UNITED STATES PATENT AND TRADEMARK OFFICE

APPLICATION NO.	FILING DATE	FIRST NAMED INVENTOR	ATTORNEY DOCKET NO.	CONFIRMATION NO.
10/600,065	06/20/2003	Ming-Huei Shieh	AF01169/AMDP975US	5651

Office Action Summary

Response to Amendment

FIG. 9

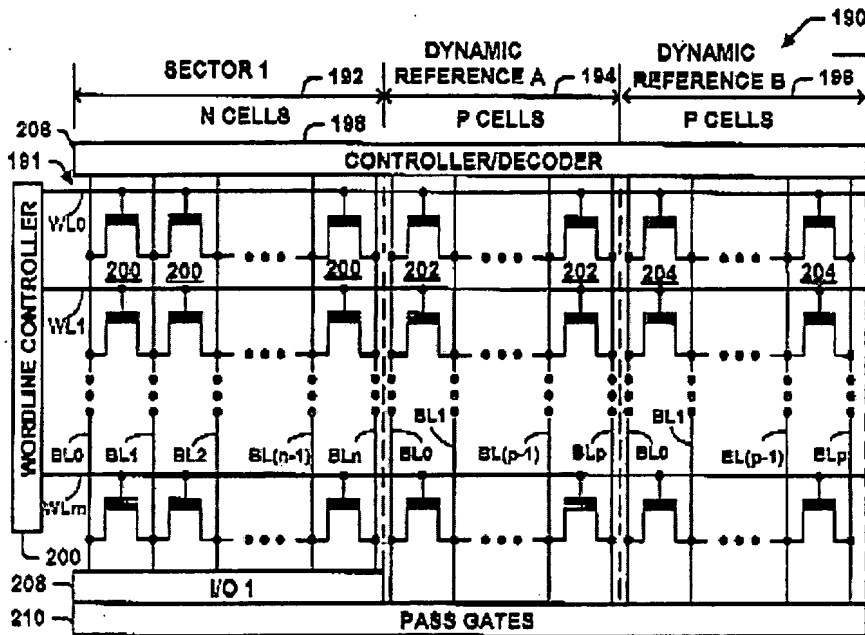
Under remarks, with respect to claims 1, 13, 15-17, 24 and 27, applicant argued that Van Buskirk does not disclose "the first and second reference arrays each comprised of a plurality of multi-bit reference cells fabricated on the memory core, wherein reference cells within the first reference array have a first voltage level and reference cells within the second reference array have a second voltage level, the second voltage level different than the first voltage level". Examiner respectfully disagrees for the following reasons:

Figs. 9 and 10 of Van Buskirk above disclose the first (Ref. A) and second (Ref. B) reference arrays each comprised of a plurality of multi-bit reference cells (202s and 204s) fabricated on the memory core (210 Fig. 10), Van Buskirk does not clearly disclose wherein reference cells within the first reference array have a first voltage level and reference cells within the second reference array have a second disparate voltage level. However, It must be used two disparate voltages to form an average as disclosed

in fig. 5; since if two voltages are the same then can not do an average for example: If the first voltage is 5V and second voltage is 5V then the average is 5V. Therefore, the voltages of those two levels must be different.
